AN timeout and restart mechanism

Comments #234, #282

Adee Ran, Cisco

Figure 73–11—Arbitration state diagram

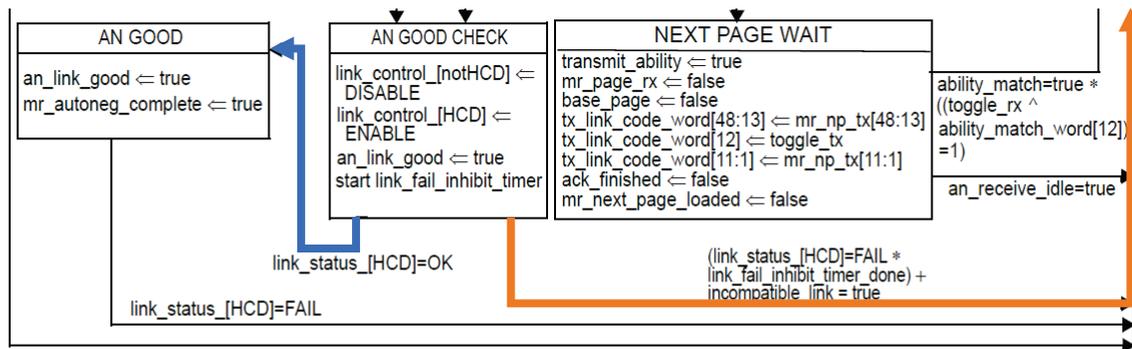
With the existing AN arbitration state diagram, link_fail_inhibit_timer is both “max time-to-link” and “min time-to-retry”.

The choice between these paths is done by the link_status parameter of AN_SIGNAL.indication (generated by the PCS).

We don't want to change the state diagram!
but we can assign new meaning to link_status in new PHYs
(as we did with the SIGNAL_OK parameter of IS_SIGNAL)

Figure 73–11—Arbitration state diagram

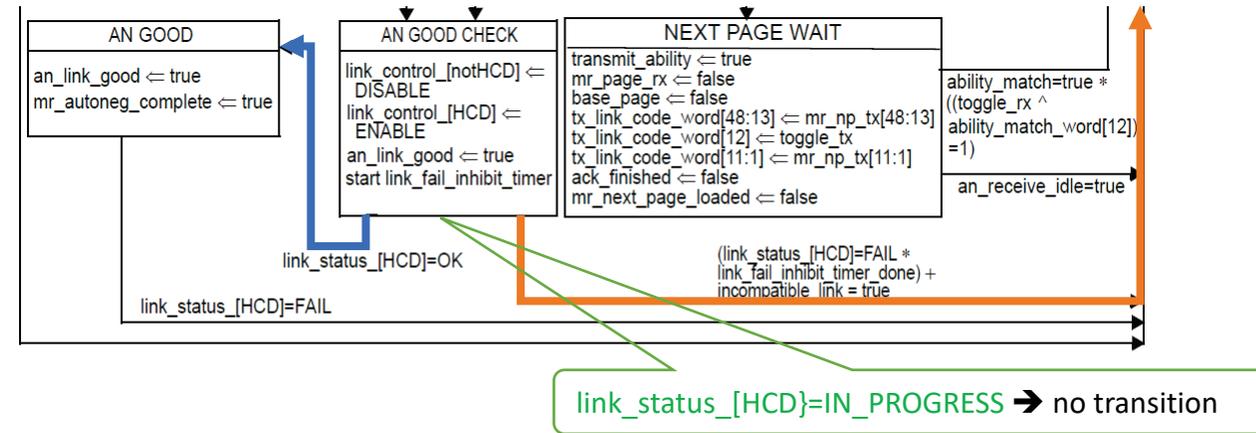
- Add a third possible value, IN_PROGRESS.
- link_status=IN_PROGRESS will keep the state diagram in “AN GOOD CHECK” state, preventing AN from restarting.
- The PCS generates IN_PROGRESS while ILT has not completed (and thus the PCS does not receive valid data and cannot align).
 - This is indicated in the PCS by having SIGNAL_OK of either IN_PROGRESS or READY in PMA:IS_SIGNAL.indication into the PCS.
- When ILT is completed everywhere, RTS propagation will cause SIGNAL_OK to become OK.
 - This will cause signal_ok = true in the PCS.

Figure 178B–8—Training control state diagram

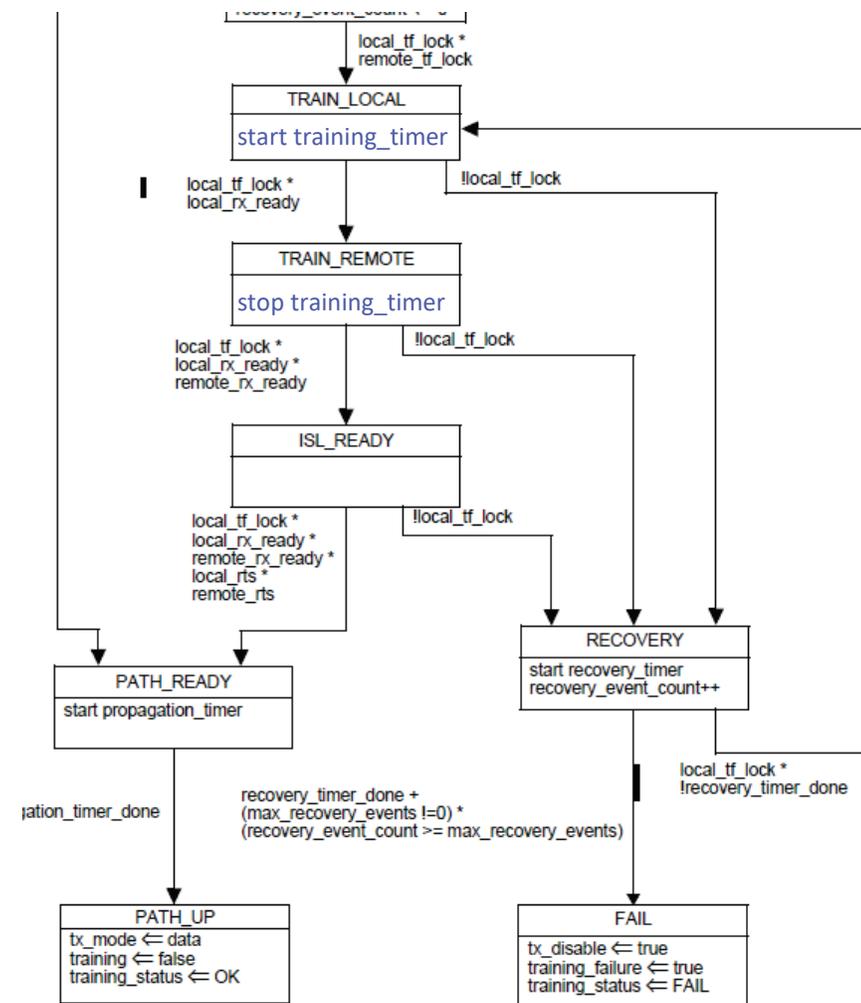
This timer is started when the training control state diagram on a lane enters the TRAIN_LOCAL state (see Figure 178B–8). The terminal count of this timer is controlled by the management variable mr_training_timer_duration. The effect of expiration of this timer is implementation dependent.

Add MDIO mapping for **mr_training_timer_duration** (RW) and **training_timer_done** (RO) in Table 178B–6 and in Clause 45.

Add default values of mr_training_timer_duration: in clauses 178 and 179 – 60, in annexes 176C and 176D – 0.
